ARPANSA Regulatory Assessment of Replacement Reactor Construction Application

9 August 2001 Reactive Review Questions and Issues

PSAR Chapter 12.3 Reactor Facility Design for Radiological Safety (continued)

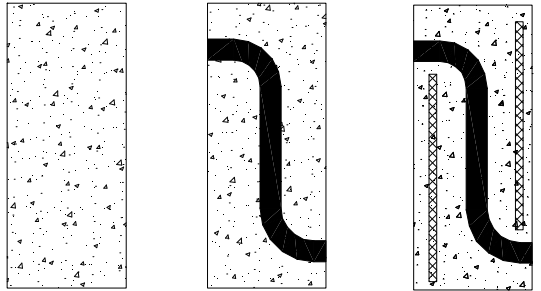
Response: By an ASNO approved system via an airlock.
12.48.	12.3.1.2 Component Layout	"b) ... Bent pipes are used in shielding wall crossings and, as appropriate, thickness reduction of shielding is compensated."	What is meant by "the thickness reduction of shielding is compensated" ?

Question reference	Section number and name	Topic for clarification	ARPANSA Comment, Issue or Question and ANSTO Response
			<p>Response: A pipe embedded in a shield behaves as a void reducing the amount of attenuation material. In order to Keep the shield thickness constant, this removed material needs to be compensated by replacing part of the original shield material by other (generally concrete is replaced by lead or steel) with equal or greater attenuation properties. In other cases the wall thickness is greater than that required by the calculations in such a way that the concrete itself is used to compensate the possible addition of a pipe.</p> <div style="text-align: center;">  <p style="text-align: center;"> Original Shield Original Shield with embedded pipe Original Shield with embedded pipe and compensation material </p> </div>
